Rezoning Application: PRS 25-0664

**Hillsborough
County Florida**

Development Services Department

Introduction Summary

2.3 Approved Site Plan (partial provided below for size and orientation purposes. See Section 8.1 for full site plan)

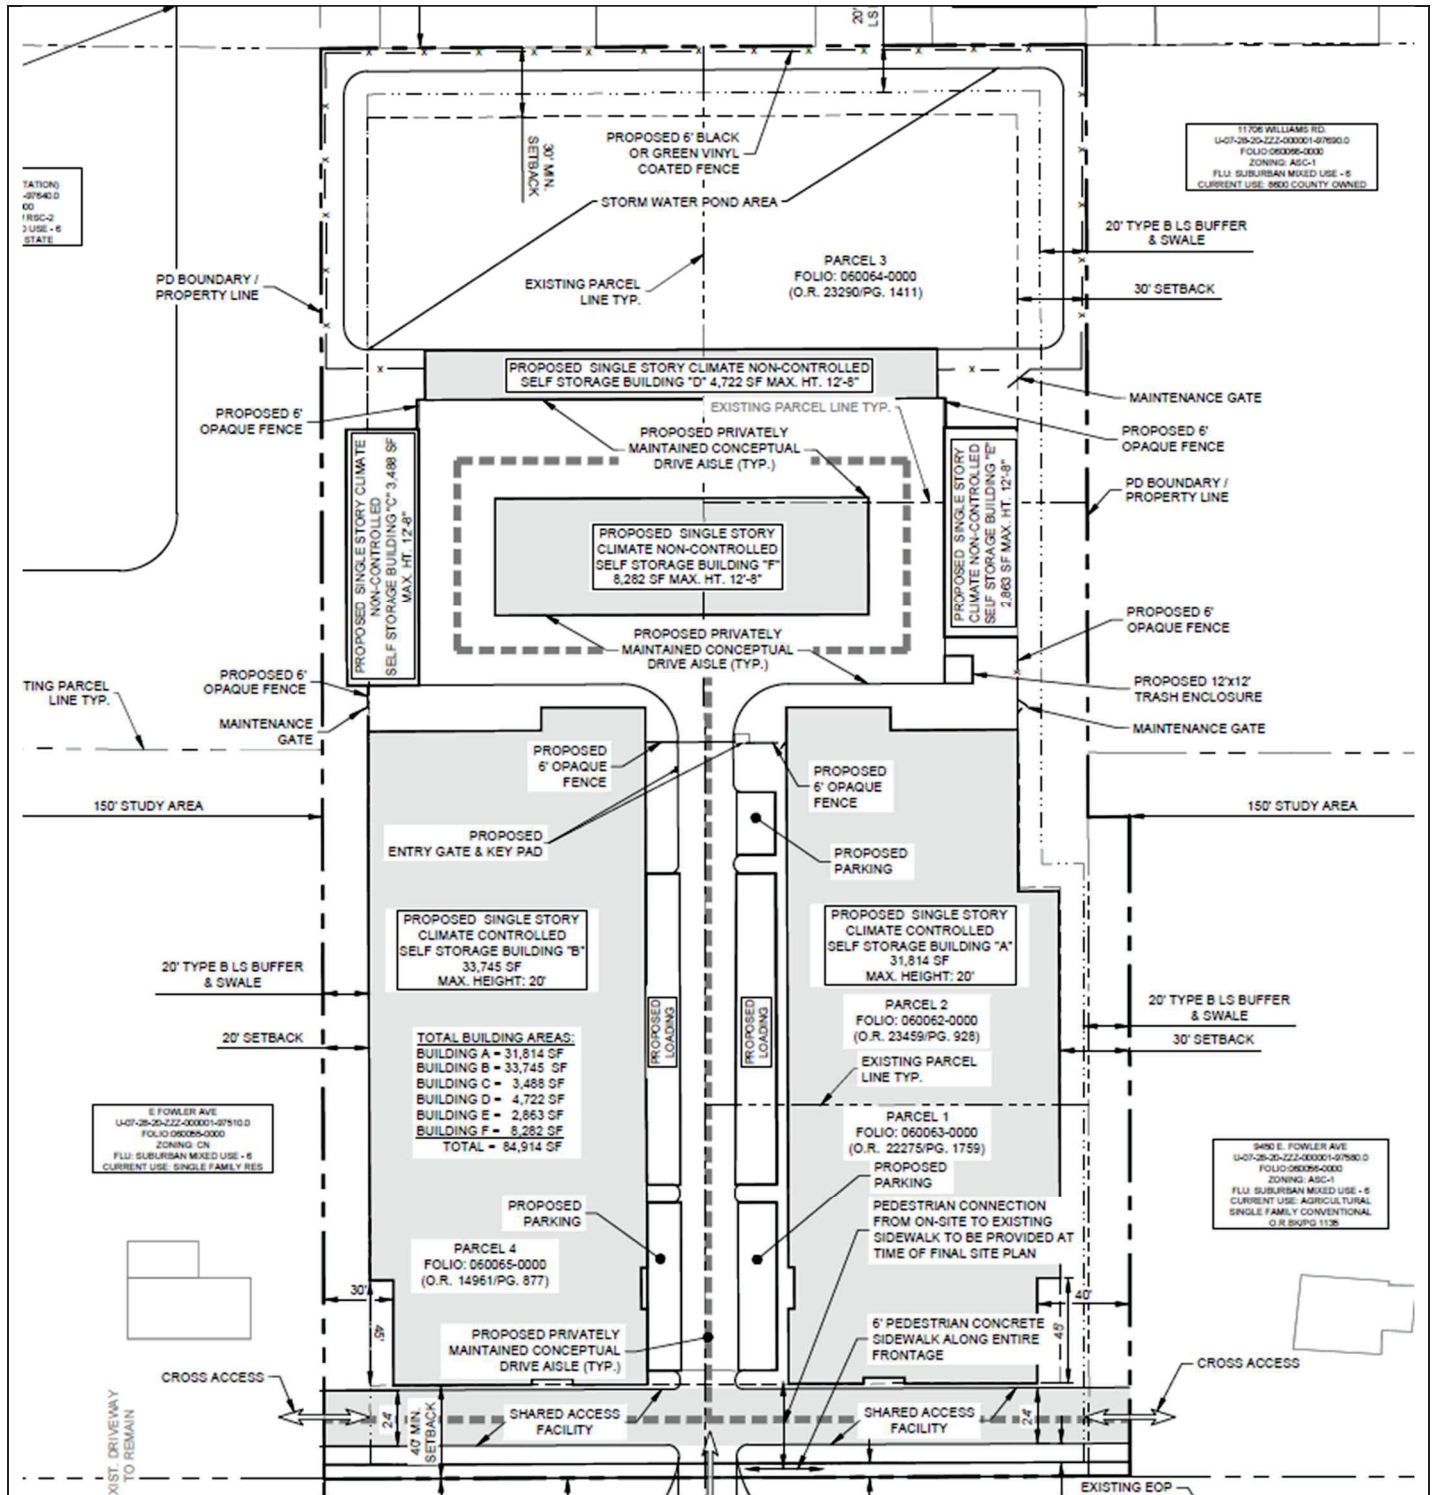
**CURRENTLY
APPROVED**

2.4 Proposed Site Plan (partial provided below for size and orientation purposes. See Section 8.0 for full site plan)

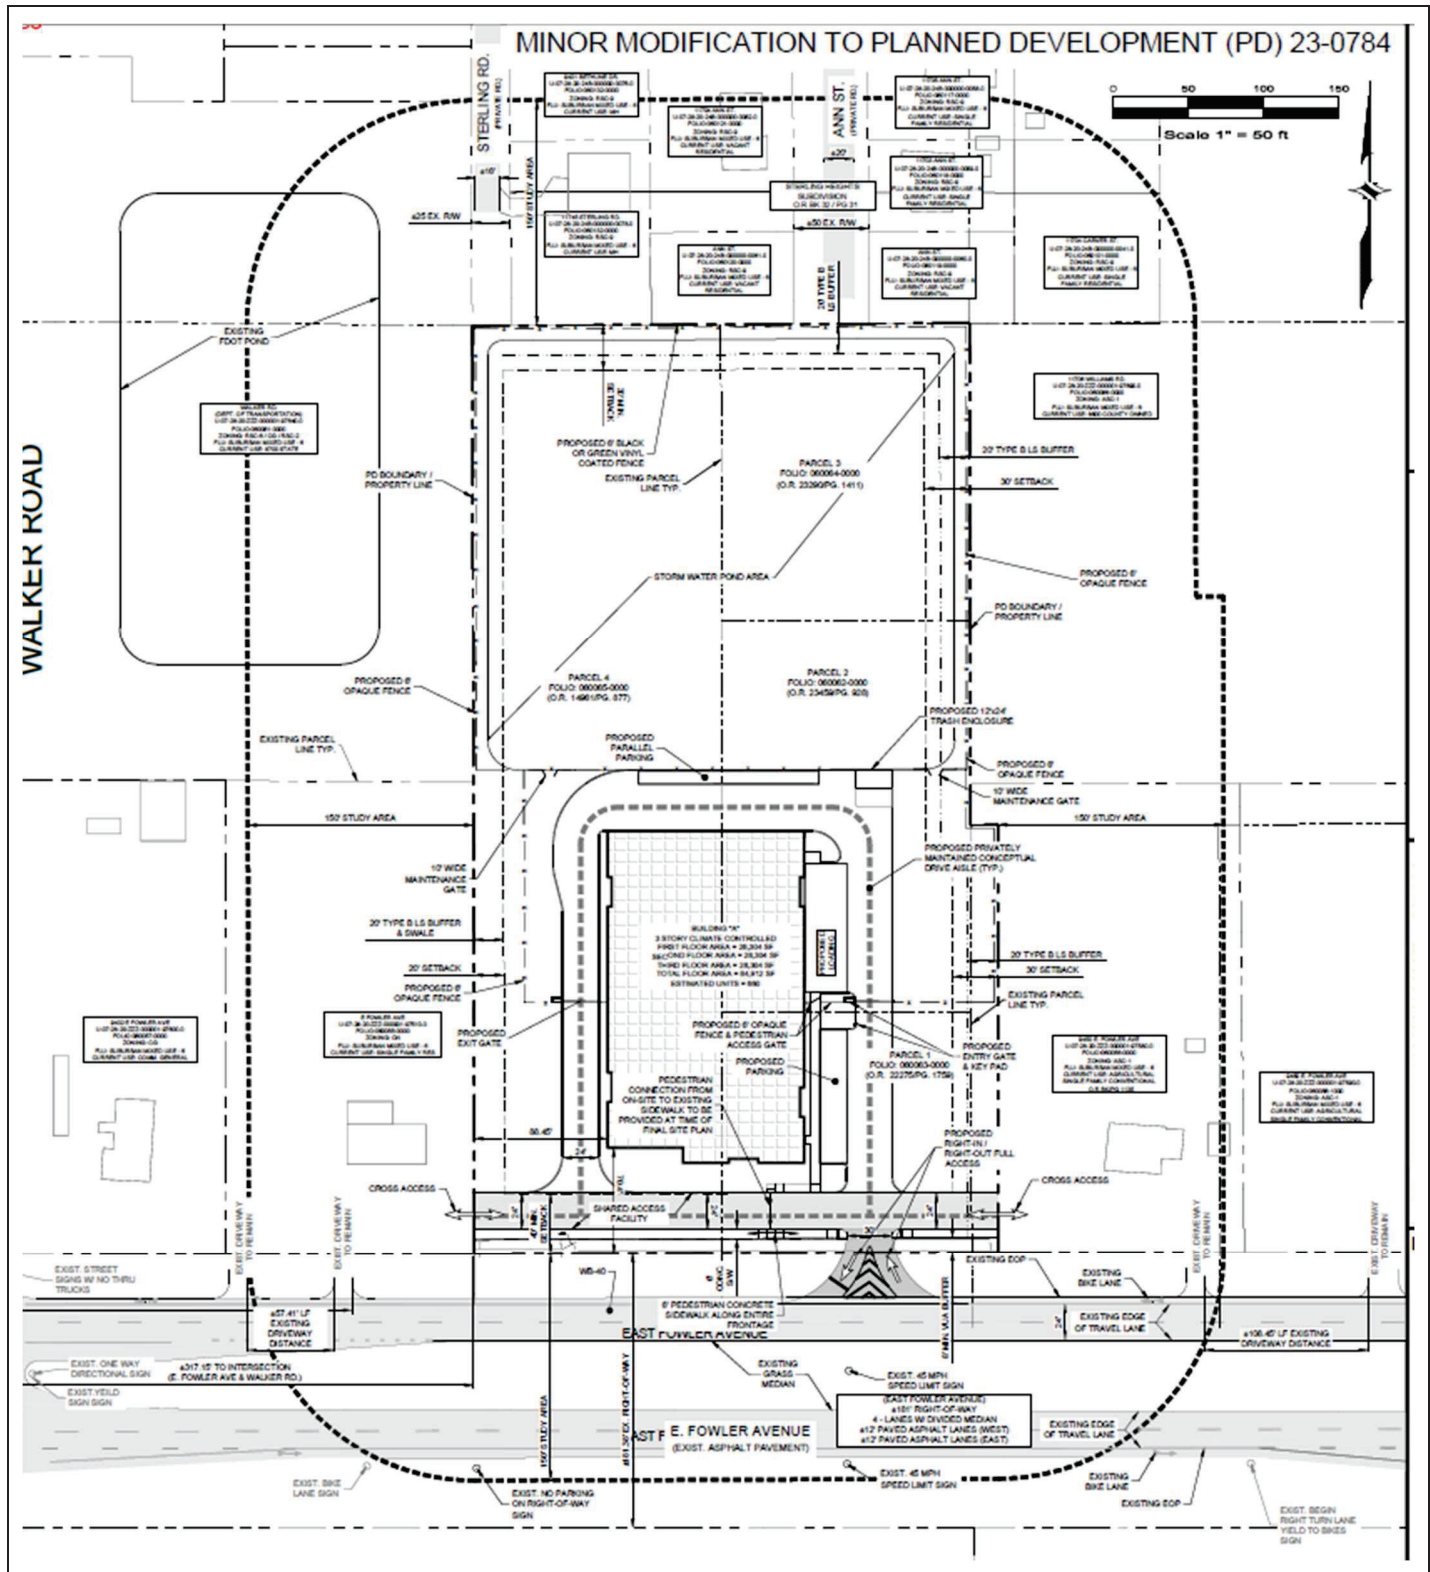
PD 23-0784 was approved in 2023 to accommodate the development of a mini warehouse facility consisting of six buildings with up to 84,914 square feet (SF) of gross floor area (GFA). The applicant is requesting a minor modification to reconfigure the general development plan and increase the allowable height and number of storage units.

Existing Approvals	Proposed Modifications
Six mini ware house buildings with up to 84,914 square feet and up to 640 storage units	One mini warehouse building with up to 84,912 square feet and up to 660 storage units.
Maximum building heights ranging from 12' - 8" to 20'.	Increase maximum building height to 35 feet.
Access from Fowler Avenue is located near the midpoint of the southern property boundary.	Shift of the Fowler Avenue access point east.

Approval - Approval of the request, subject to the conditions listed below, is based on the general site plan submitted ~~September 27, 2023~~ April 2, 2025.

1. Development shall be limited to ~~84,914~~ 84,912 SF of mini warehousing subject to the following conditions.
 - 1.1 Such facilities shall be used only for dead storage of materials or articles and shall not be used for assembly, fabrication, processing, or repair.

6. The following building requirements shall apply to the mini warehouse facility ~~to Buildings A and B.~~
 - 6.1 ~~Buildings A and B~~ The building must include 10-foot by 45-foot articulations as depicted on the general development plan.
